### WP-25-12

Wetlands Permitting

Construction of driveway and associated stormwater controls for new home site

## **Narrative for the Implementation of E & S and Stormwater Management Measures Proposed 15.56 Acre Building Site on Route 44**

**STORM WATER INFILTRATION TRENCH MAINTENANCE PLAN**

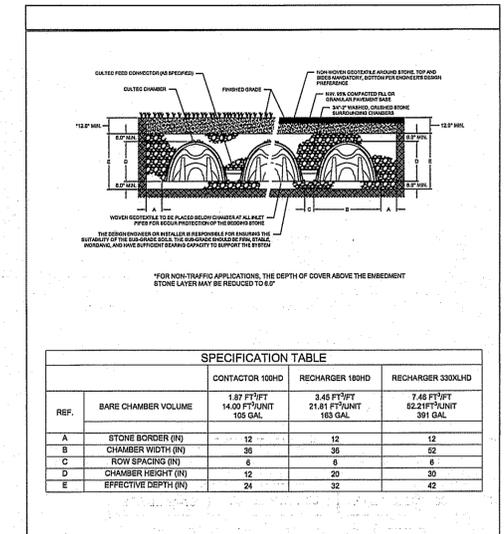
- Infiltration Trench:
  - Are the two walls at the easterly limit of said trenches to act as weirs? If yes it would be good to have more detail grades and info to make sure they are constructed to the intended design.

**ROOF STORMWATER INFILTRATOR DETAILS**  
NOT TO SCALE

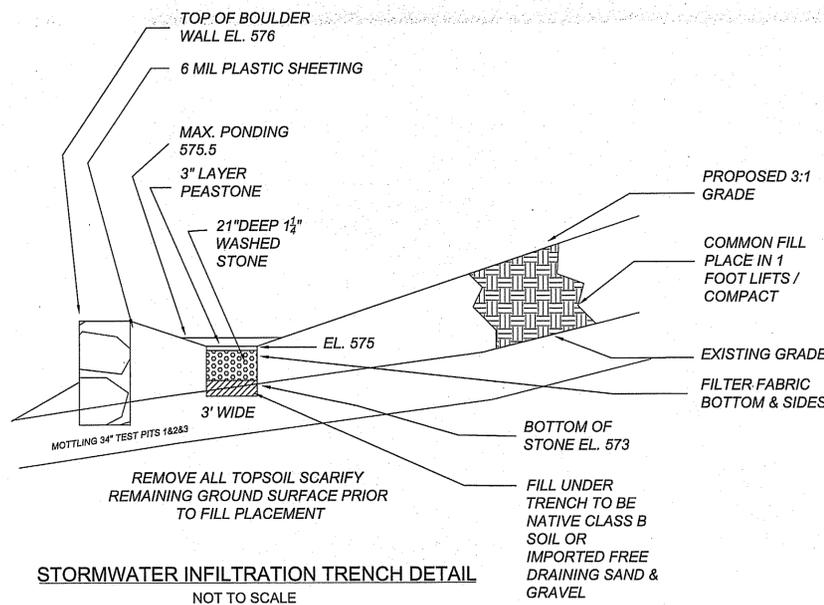
- Please explain why a 20foot driveway is being proposed again?
- Proposed plan should depict the connectivity between the house roof leaders and the proposed house infiltrators.

CROSS SECTION

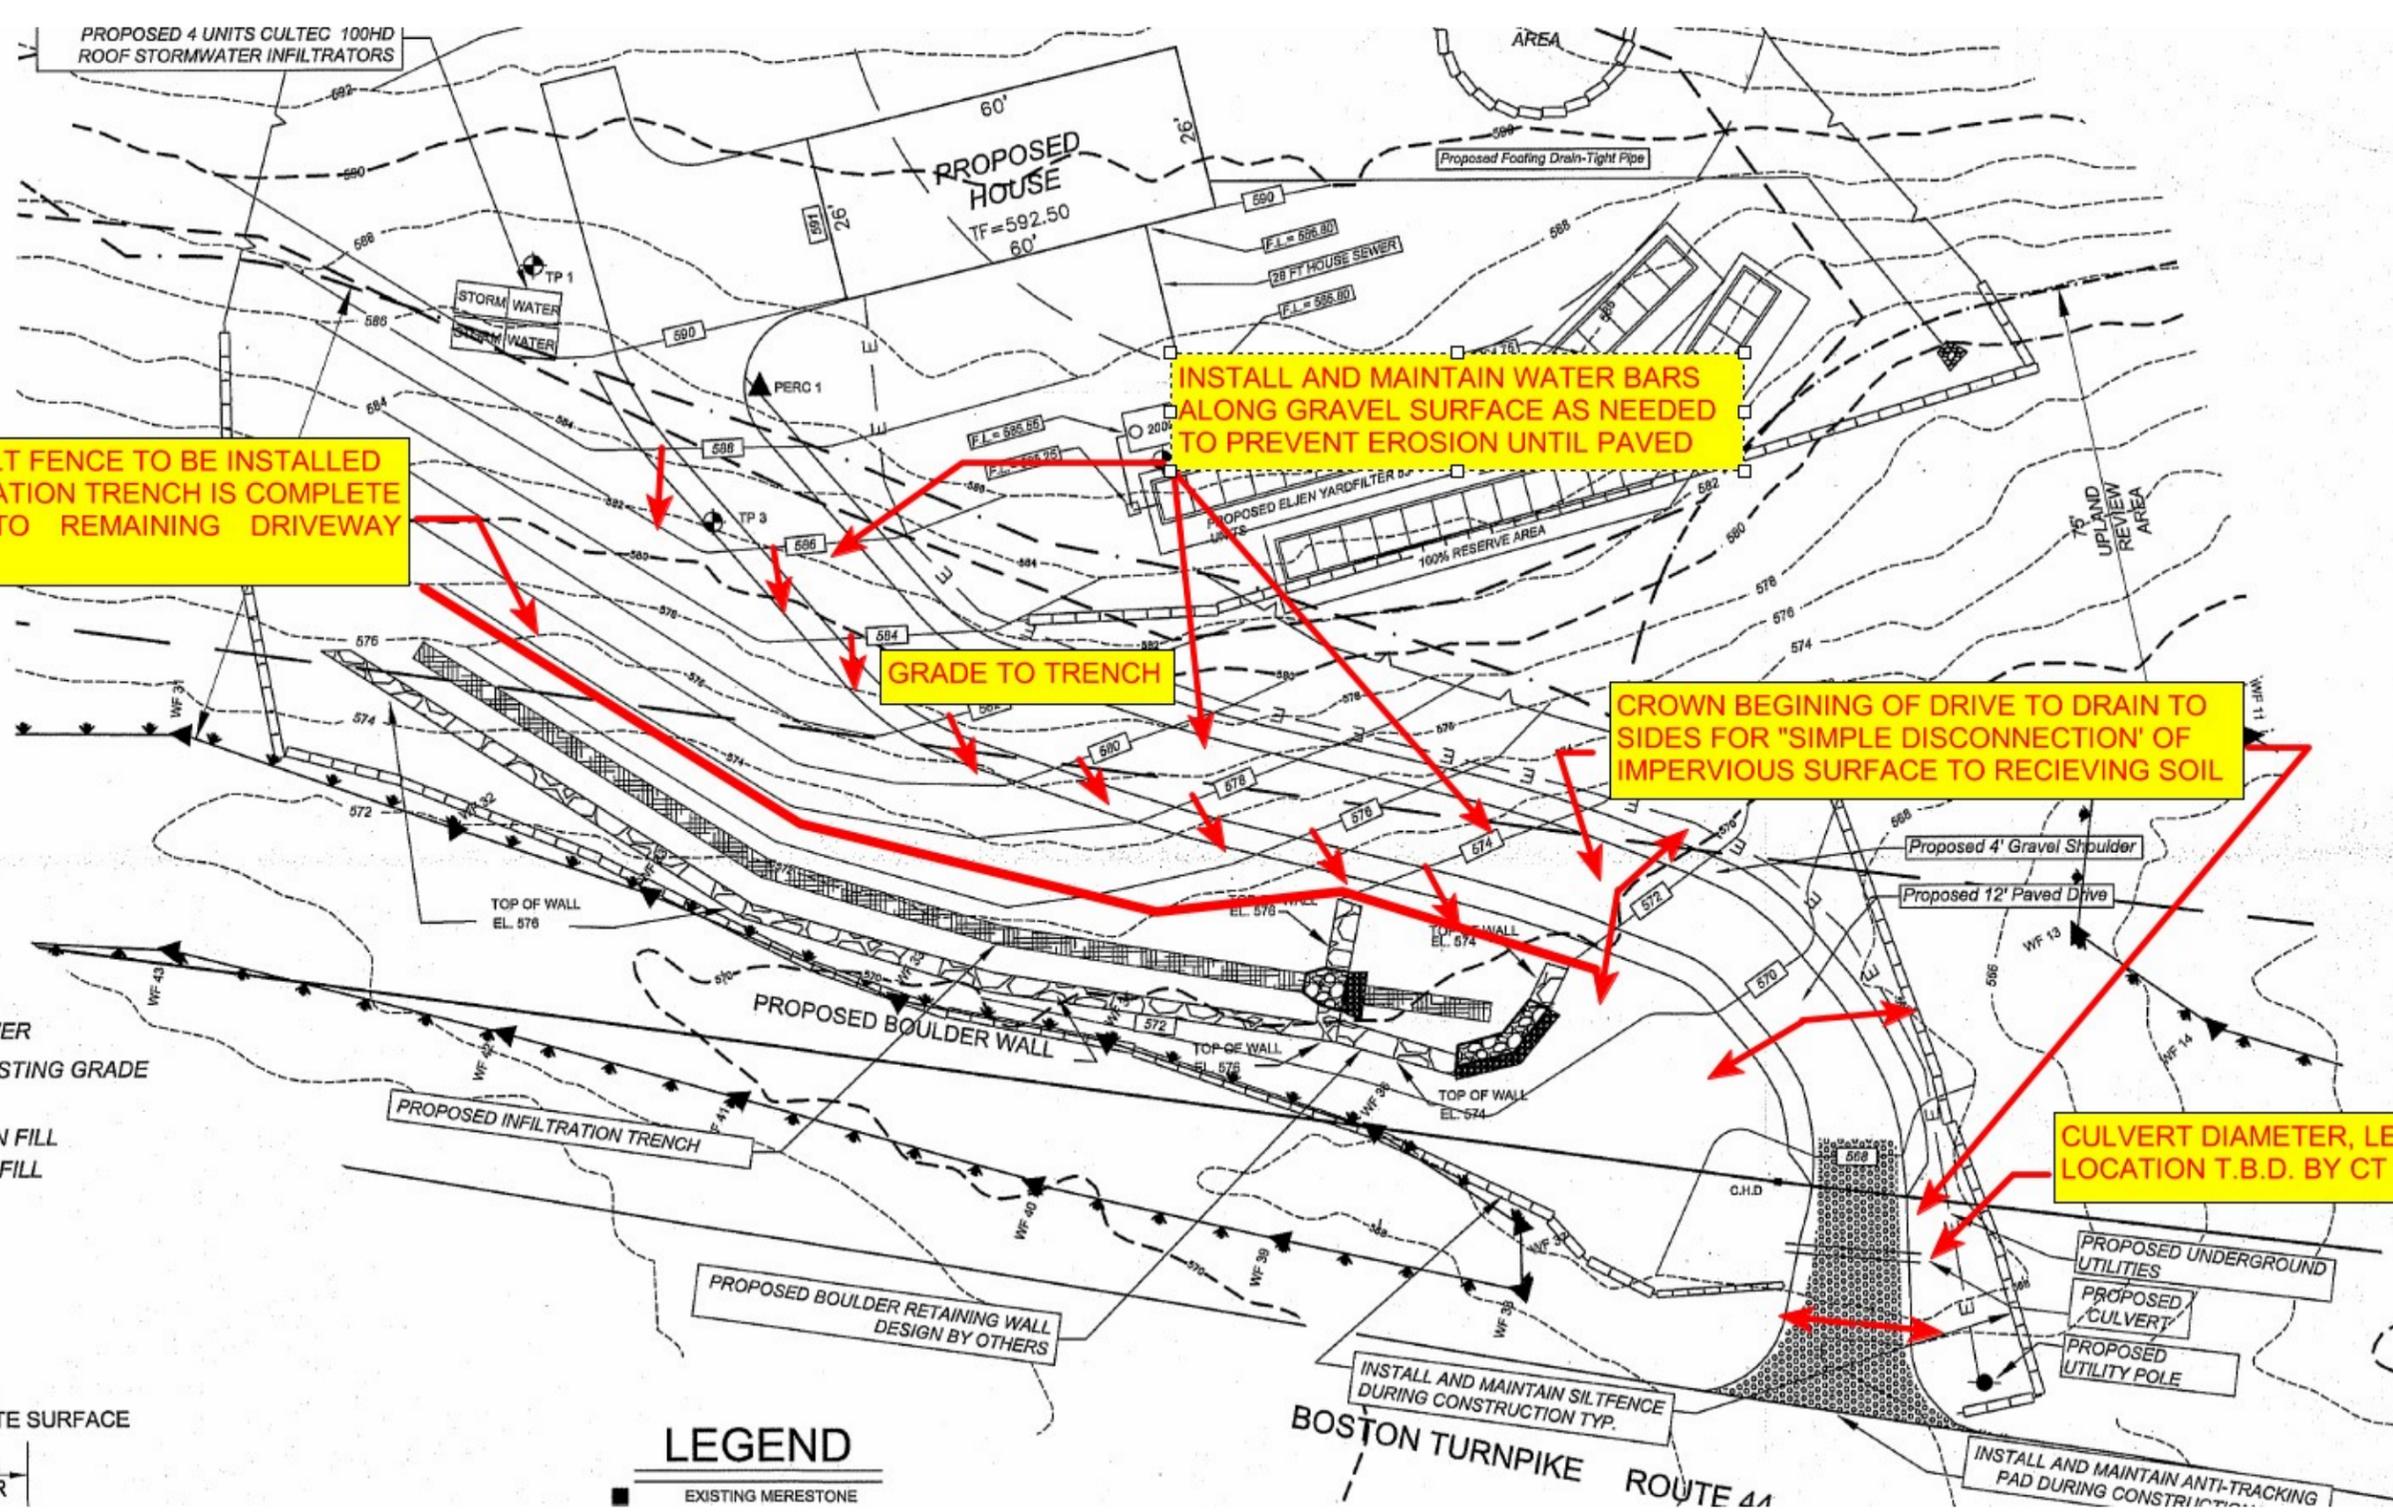
- Provide additional details regarding pitch of driveway to explain how stormwater runoff is directed into the infiltration trenches on the engineered site plan.

- Depict the proposed grades from Boston Turnpike thru proposed contour 572 as a crown for the driveway as noted by Brown's sketch. A note should be added that any deviation to the proposed grading for all of the development will require Town Staff approval and may require Inland Wetlands Agency approval.
